## Question 5. Proposed new school building plan, w/one entrance off Strong Street for 750-student pick-up and drop-off.

SCHOOL BUILDING PROJECT

## SITE PLAN

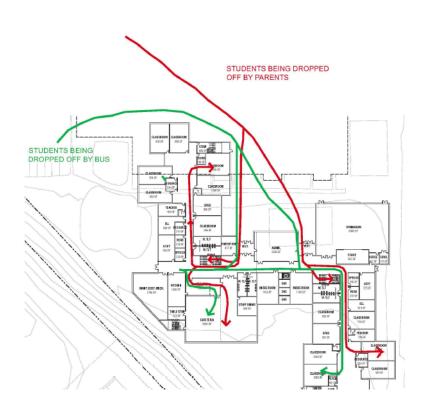
This is the **site plan**. Note that Wildwood is on a hill, with slopes on 3 sides — immediately behind to the middle school; at the back of the proposed new building; and from Strong Street down to the school.

Exhibit A - Student Site Circulation - Phase 2 Arrival

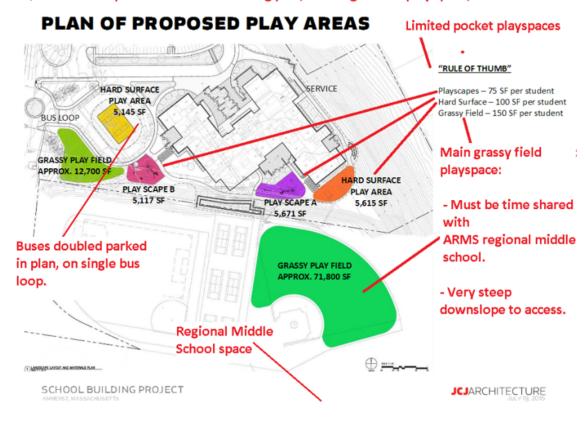
This chart shows student flow from the parent carloop and the busloop into the entrance plaza. (p. 622 of the Schematic Design)

Question 5. Proposed new school building plan, showing limited play space, crowded bus

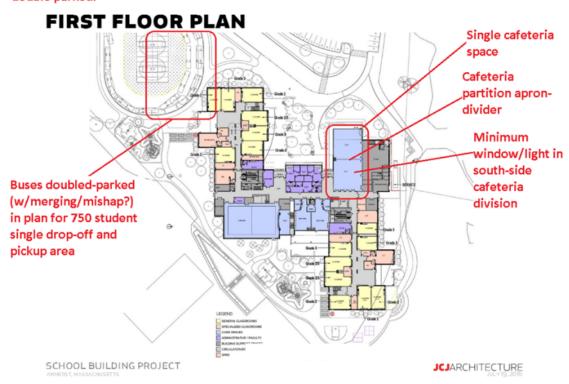
This is the plan of proposed play areas.

2 of 4 play spaces are on asphalt.

There is no single large grassy play field: the designated field is not large enough to put a soccer pitch. Kids may time-share the middle school's play field, down a fairly steep slope, that will require maintenance and additional funding for an ADAaccessible ramp.
